Comments on applications for referral under the COVID-19 Recovery (Fast-track Consenting) Act 2020

| Project name | Northbrook Wanaka Retirement Village |

| General comment | Winton Northbrook Northlake Retirement Village |

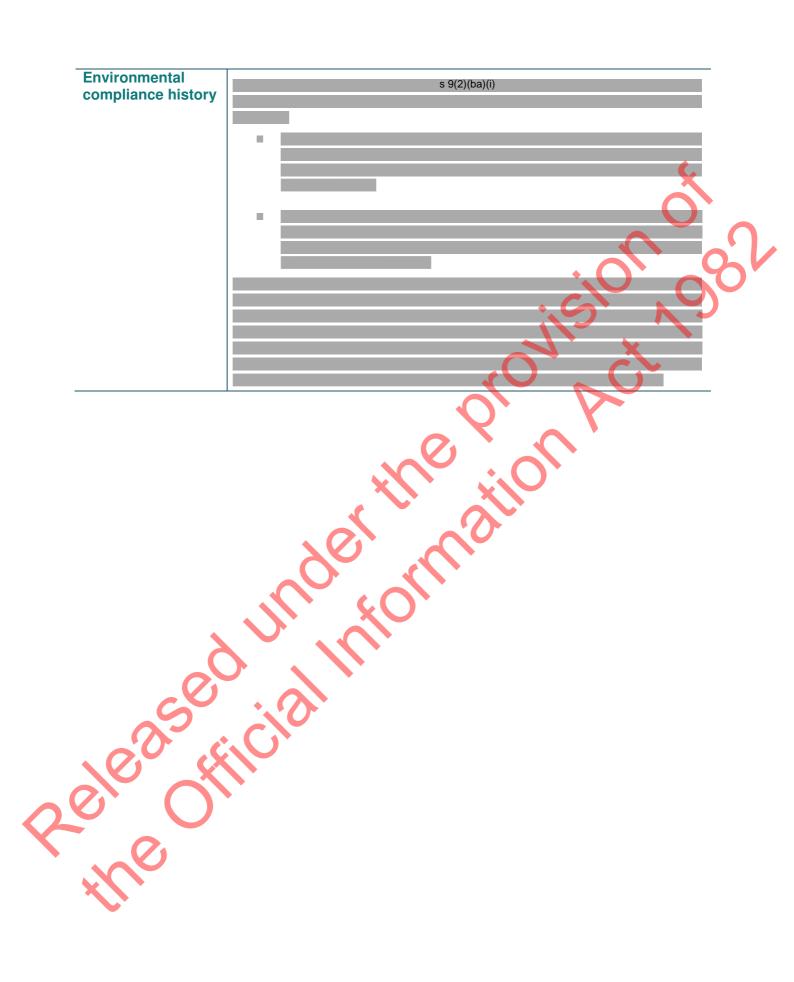
The proposal does not contain information on how they would control stormwater from the site. The site is in close proximity to Clutha River. There was no information on where hardstand stormwater from roads, houses etc would discharge to. Considering the history of the Albert Town, stronger information and AEE on stormwater control is needed.
